## Index 102-661 Bicycle Lane Closures

### COMMENTARY

LAST REVISION 11/01/21	REVISION	DESCRIPTION:	 FY 2022-23 STANDARD PLANS	BICYCLE FACILITY CLOSURES	INDEX 102-661	SHEET 2 of 2
---------------------------	----------	--------------	----------------------------------	---------------------------	------------------	-----------------

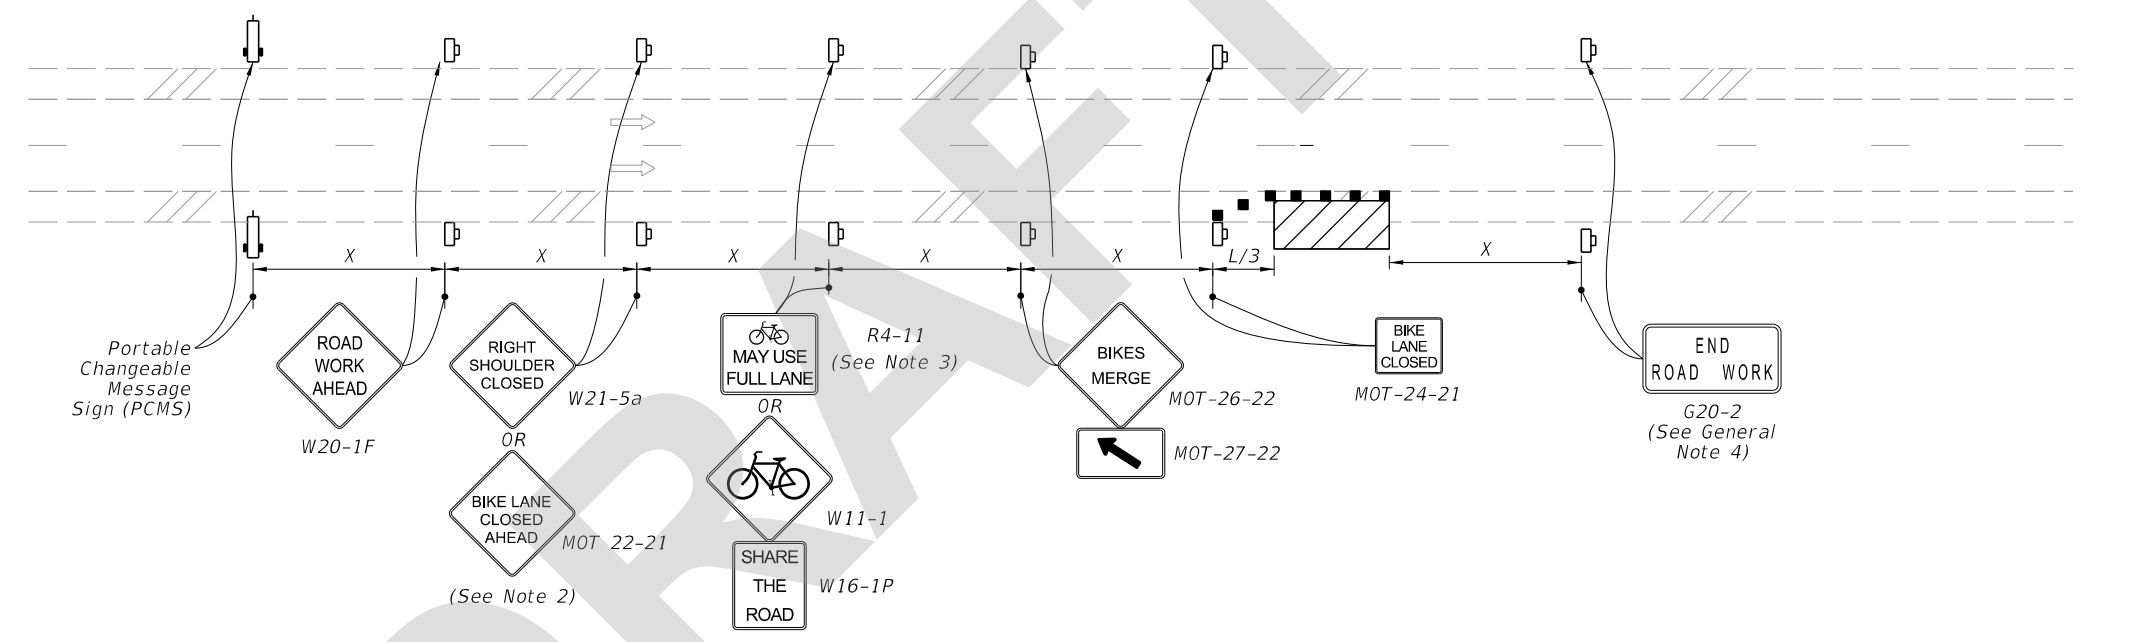
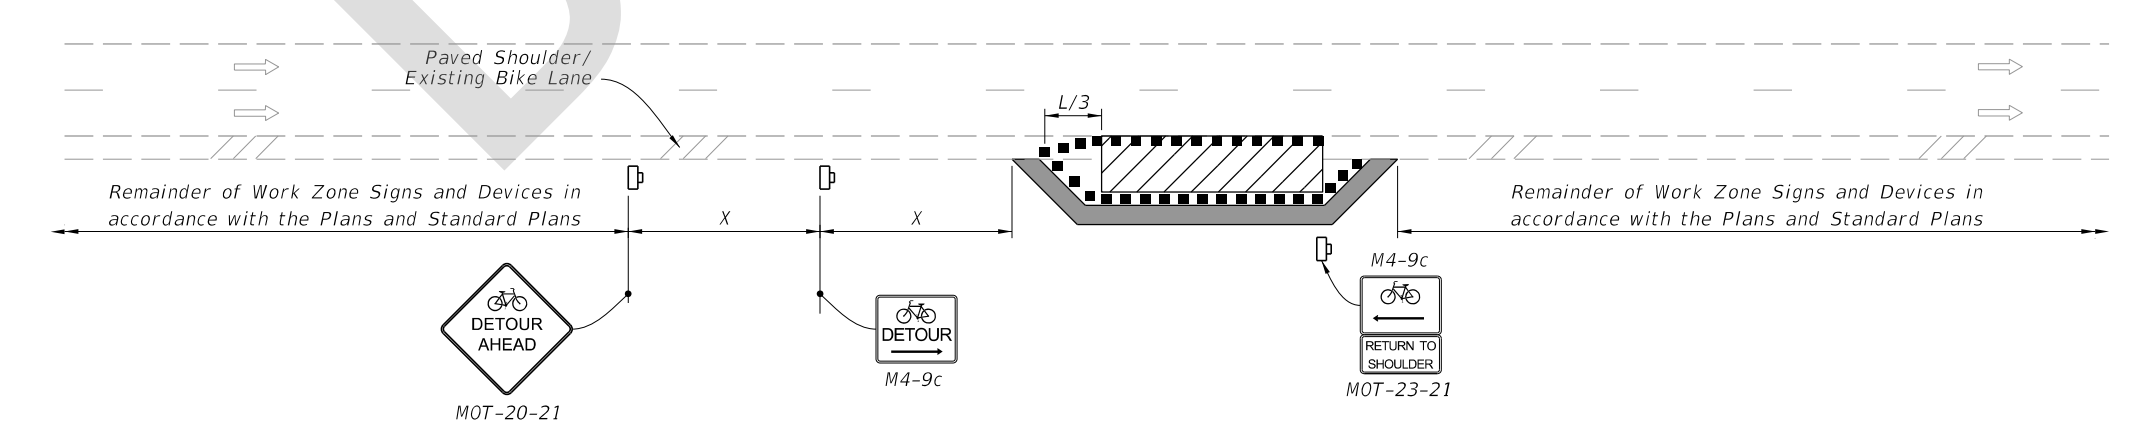
**COMMENT:** Notes on Sheet 1 – note 3 directs the contractor to provide a 5’ min. bike path, but FDOT doesn’t have any criteria for bike paths. Was this supposed to say bike lane? Sheet 1 Label - Since this example on sheet 1 uses bicycle lane signs as part of the detour signage, than detail should be labeled Bicycle Lane Detour. It would only apply when there is a bike lane. Sheet 2 – The paved shoulder/existing bike lane message needs to be replicated on the bottom example. And should it be “existing bike lane or paved shoulder”?

**RESPONSE:** We specifically didn’t want to use the term “lane” in Note #3. Calling something a “lane” has specific connotations. Plus it might not be a “Lane” might just be an existing paved shoulder. “Path” was intended to be generic. We use the terms “Lane”, “Way”, “Diversion”, etc in reference to specific things. In Note #3 we are just saying that they all must be Min. 5-ft. Disagree on the title change. The title was changed to Bike Facility Closures because there are 2 diversions and 1 detour shown on sheet 2 and the new title captures all of what is shown. Agreed that that the paved shoulder/bike lane callout should be added to the bottom detail of sheet 2.

**Change made to Index:** An additional “paved shoulder/ bike lane” callout will be added to the bottom detail of sheet 2.
